**ADDENDUM #001**

**Gymnasium HVAC Upgrades – St. Philomena CES, Fort Erie  
Tender #T24-001**

**AD  
SK-01**

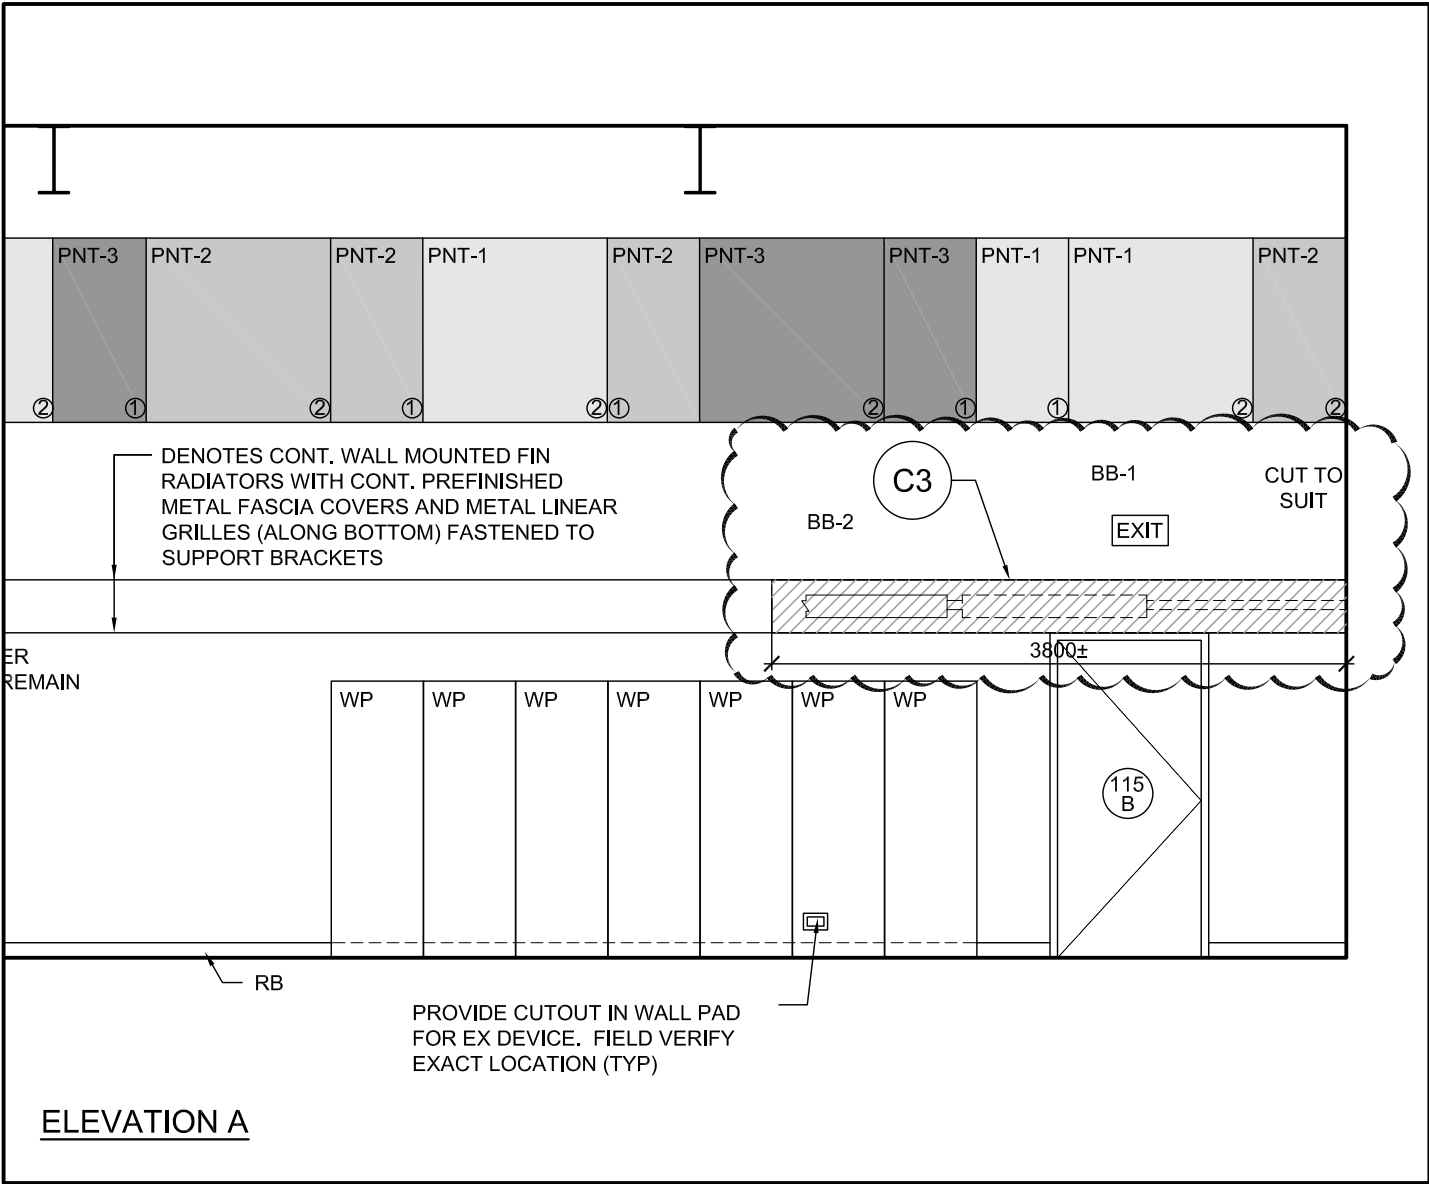
- Item 1      Refer to the attached SK-01: provide temporary removal and reinstallation of existing linear wall fin radiator and associated components and fascia cover, as needed to provide access for the installation of the new exterior doorway and lintel in the gymnasium. Also refer to Mechanical Addendum No. 1

- C3
- REMOVE TWO EXISTING METAL FASCIA RADIATOR COVER SEGMENTS (SHOWN HATCHED), CONT BOTTOM GRILLES AND SUPPORT BRACKETS AS NEEDED TO FACILITATE TEMPORARY REMOVAL OF 1200mm ± LONG RADIATOR SEGMENTS AND ASSOCIATED PIPING TO SUIT. THIS IS TO PROVIDE TEMPORARY ACCESS TO ALLOW FOR INSTALLATION OF NEW DOOR LINTEL. RADIATOR, COMPONENTS AND COVER TO BE REINSTALLED AFTER LINTEL INSTALLATION. REFER TO AND COORDINATE WITH MECHANICAL AND STRUCTURAL DRAWINGS.
